### Remarks

The objection to the Drawing has been addressed by comments below, accompanied by the editorial amendment of Figures 12-16. Replacement sheets and annotated sheets are provided. In turn, the objection to the disclosure is rendered moot by the accompanying amendment to the Brief Description of the Drawing.

FIG. 14

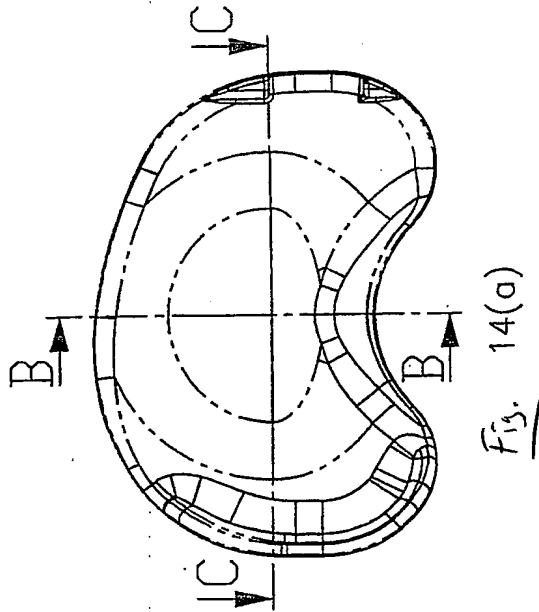
~~SECTION B-B~~  
FIG. 14(b)

~~SECTION C-C~~  
FIG. 14(c)

FIG. 15

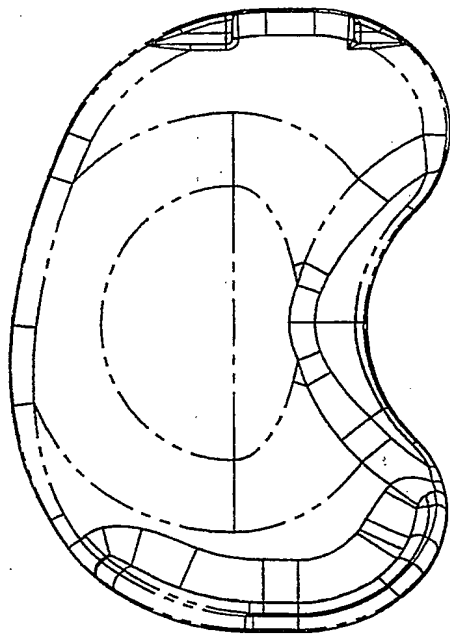
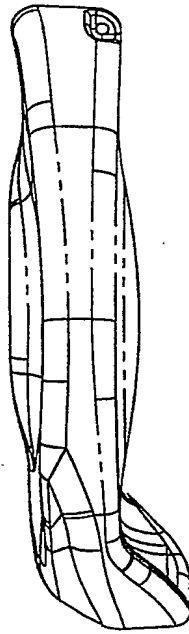
~~SIDE PLAN VIEW~~

~~TOP PLAN VIEW~~

~~FRONT PLAN VIEW~~
